LEXINGTON ARCHITECTURAL REVIEW BOARD

Staff Report Lexington, VA Historic Downtown Preservation District COA COA 2024-28 Exterior Improvements to the Rockbridge & Grand Buildings

Project Name Exterior Improvements to the Rockbridge & Grand Buildings

Re: COA Submittal for 17 S. Main Street (Rockbridge Building)

Exterior Elevation - Washington Street

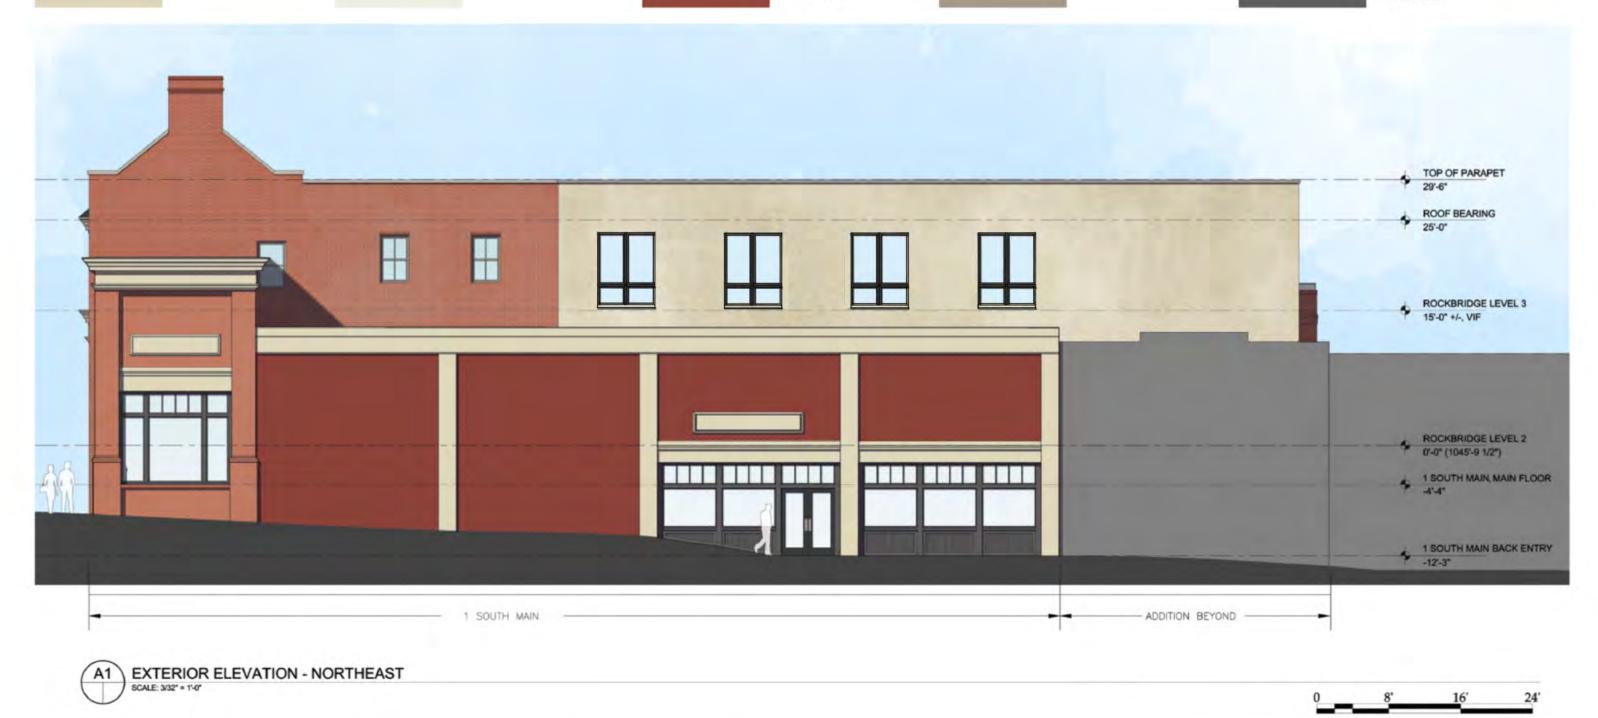
On August 15, 2024, the ARB approved the third level addition as shown on the northeast elevation drawing, with four windows notionally in the location shown, exact placement to be confirmed and a new elevation provided.

CURRENT STATUS: Northeast elevation approved with the caveat that Applicant provide alternatives to the glazing, mullion style and color of the windows and door unit, including the fiber cement vertical spine.

Submitted graphic showing updated window details to reflect our current preferred option.

Exterior Elevation - Southwest August 8 , 2024 Rockbridge Building Renovation & Connecting Spine

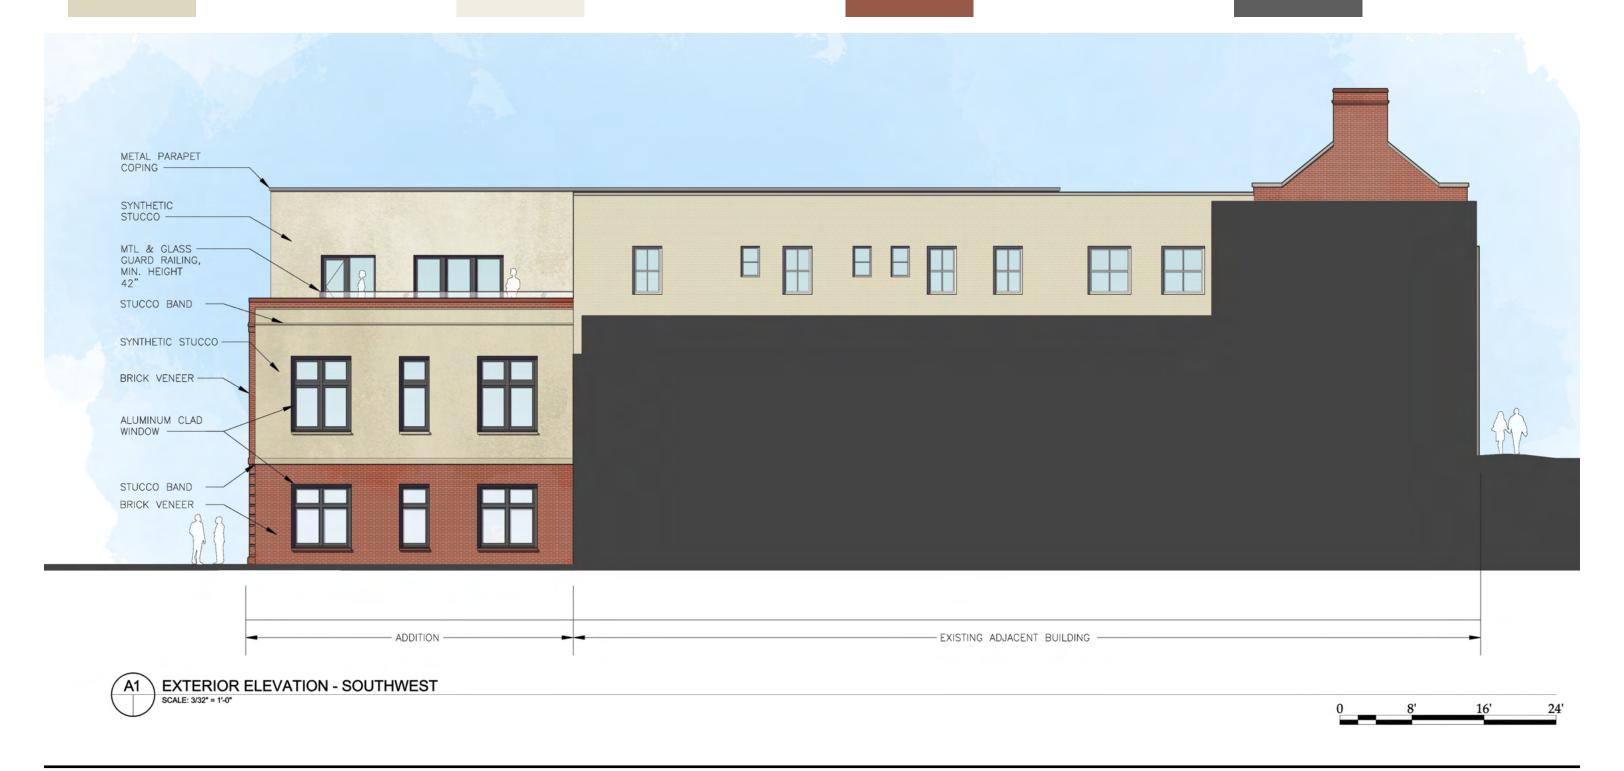
On August 15, 2024, the ARB approved the southwest elevation as proposed by the applicant with the exception of the windows and directed the applicant to provide window options in a different color and with a different mullion style.

CURRENT STATUS: Southwest elevation approved with the caveat that Applicant provide alternatives to the glazing, mullion style and color of the windows and door unit, including the fiber cement vertical spine.

Submitted graphic showing updated window details to reflect our current preferred option.
